<b>ITEM: 6.1</b>	<b>COMMITTEE OF ADJUSTMENT REPORT SUMMARY MINOR VARIANCE APPLICATION FILE NUMBER A036/23 27 GOODMAN CRESCENT, MAPLE</b>
------------------	---

**COMMITTEE OF ADJUSTMENT REPORT  
MINOR VARIANCE APPLICATION  
A036/23  
27 GOODMAN CRESCENT, MAPLE**

# A036/23

SITE PLAN

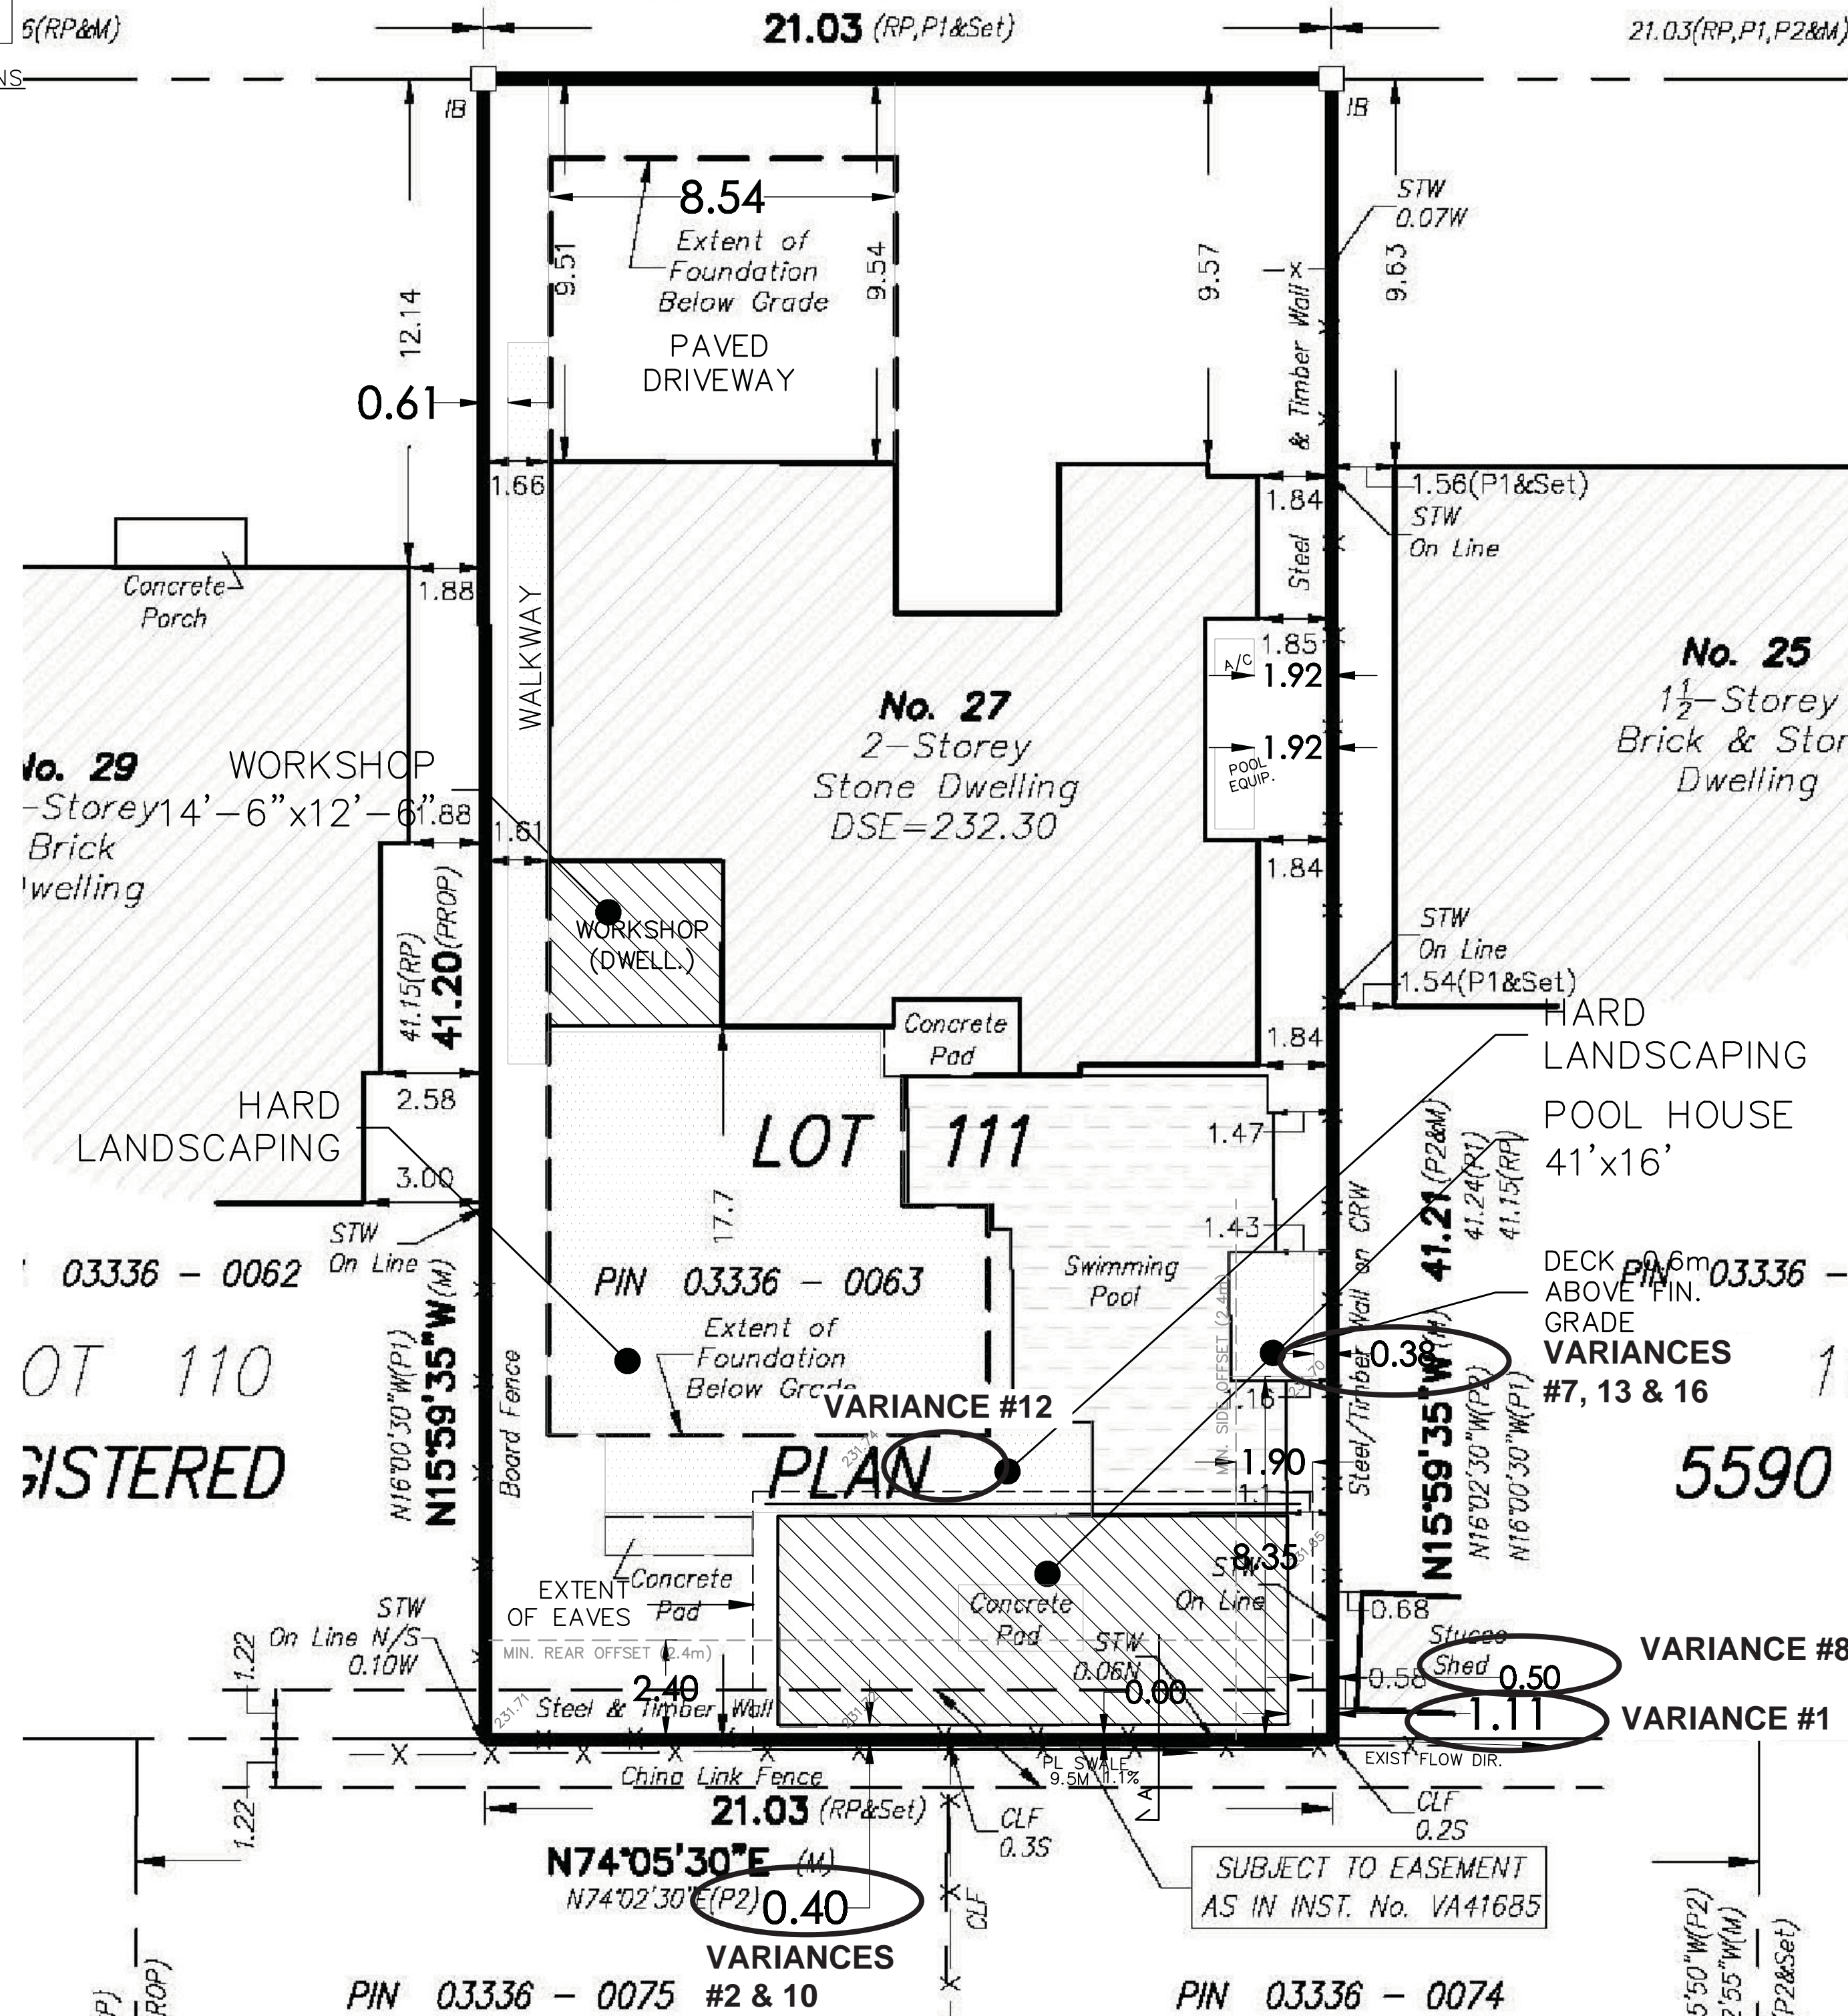
2. **Setbacks:** The Development Planning Department is not in a position to support the rear yard setback for the existing additional dwelling unit. While Development Engineering has reviewed the variances and have no concerns with the reduced setbacks from a lot grading and drainage perspective, Development Planning is of the opinion that a 0.4 m rear yard setback will impact the functionality and maintenance of the rear yard by providing little to no access around the additional dwelling unit structure. The application as proposed provides little separation between a dwelling unit and a rear lot line. It is anticipated this will result in significant massing and privacy impacts to abutting properties.

The Development Planning Department is of the opinion that an appropriate distance is not provided between the rear lot line and the existing additional dwelling unit and that the listed functions of an interior and rear yard setback have not been maintained.

3. **Soft Landscaping:** As per the submitted Site Plan, 39.6% soft landscaping for the portion of the rear yard in excess of 135.0 m<sup>2</sup> has been identified. In an R1E Zone, any portion of the rear yard in excess of 135.0 m<sup>2</sup> shall be comprised of a minimum 60% soft landscape. Development Planning typically aims to support reductions of soft landscaping of at least 50% for the portion of the rear yard in excess of 135.0 m<sup>2</sup> where circumstances to achieve full compliance are challenging. Development Planning understands that an underground parking garage exists below parts of the rear yard. However, placing landscaping on top of parking garages is common practice. At the moment, the only sizeable portion of soft landscaping within the rear yard is within the somewhat isolated southwest corner. The pool and associated patio amenity areas occupy the majority of the unenclosed rear yard. An increase in soft landscaping would help balance the softscape and hardscape features, improve the permeability of the rear yard, and remain compatible with other properties in the area.

The Development Planning Department is not in a position to support Variances 1, 2, 3, 6, 7, 8, 9, 10, 13, 14, 15 and 16 for the reduced interior side yard and rear yard setbacks for the ADU with a height greater than 2.8 m, a maximum encroachment of 0.61 m for the ADU's eaves and gutters into the minimum interior side yard and 0.0 m into the rear yard, a minimum interior side yard of 0 m for the post and beam structures, a maximum encroachment of 1.12 m (By-law 001-2021) and 1.5 m (By-law 1-88) for the uncovered platform into the minimum required interior side yard (east side) and 1.3 m encroachment for the attached post and beam structures on the west side of the dwelling, and deck encroachment of 0.38 m into the required interior side yard.

Development Planning is also of the opinion that permitting relief for the ADU's eaves and gutters so that they maintain a setback of 0.39 m and 0.0 m from the interior side and rear lot lines respectively are not considered minor in nature. The setbacks are inadequate. The eaves and gutters are an additional encroachment beyond the requested setback reductions for the walls of the ADU. As the walls of the ADU are already considered to be too close to the interior side and rear lot lines, the eaves and gutters further exacerbates the adverse massing and maintenance impacts created by the built form and location of the ADU.

With respect to function 1, the existing ADU does not provide adequate separation of mass between properties as the 4.29 m high ADU spans nearly the entire length of the rear yard. The height and proximity of the ADU causes it to be visible from Malaren Road, impacting its streetscape, and it will also have adverse massing impacts on the abutting residential properties. In addition, the uncovered platform located east of the inground pool elevates not only the activities to occur upon it, but the items placed upon it. This has resulted in the installation of a 9-foot fence along the interior side lot line in order to better buffer the ADU and the uncovered platform from the abutting residence and its rear yard to the east. The 9-foot fence is not sufficient to mitigate the lack of spatial separation between the ADU and the neighbouring properties. Increased setbacks are required to ensure the adequate separation and buffering of the proposed uses from the dwellings and their rear yards on the abutting properties.

Therefore, the Development Planning Department is not in a position to support Variances 4 and 5 as the proposed lot coverage for the existing 2-storey dwelling with the workshop expansion to the attached garage and the ADU is not considered to be minor in nature, do not maintain the general intent and purpose of Zoning By-law 001-2021, and will create an undesirable built form in the R1E(EN) Zone that would alter the existing character of the surrounding area.

The Development Planning Department is not in position to support Variance 11 for the reduced rear yard soft landscaping. The intent of the By-laws is to limit the amount of hardscaping on residential lots to maintain a balance between hardscaping and soft landscaping. Some of the functions of maintaining sufficient soft landscaped area include: providing sufficient space for snow storage and stormwater attenuation/infiltration, providing space for the establishment of trees, noise attenuation through introduction of soft surfaces, and mitigating urban heat island effects. At the moment, the only sizeable portion of soft landscaping within the rear yard is within the somewhat isolated southwest corner. The pool and associated patio amenity areas occupy the majority of the unenclosed rear yard. Development Planning understands that an underground parking garage exists below parts of the rear yard. However, placing landscaping on top of parking garages is common practice. The proposed 39.6% soft landscaping is a major reduction and does not meet the intent of the soft landscaping provisions nor the intent of the LLN policies under 9.1.2.3 of VOP 2010, particularly subsection (h). There is also an adverse visual impact to the character of the rear yard created by the absence of sufficient soft landscaping and the proposal is not consistent with other rear yards in the neighbourhood.
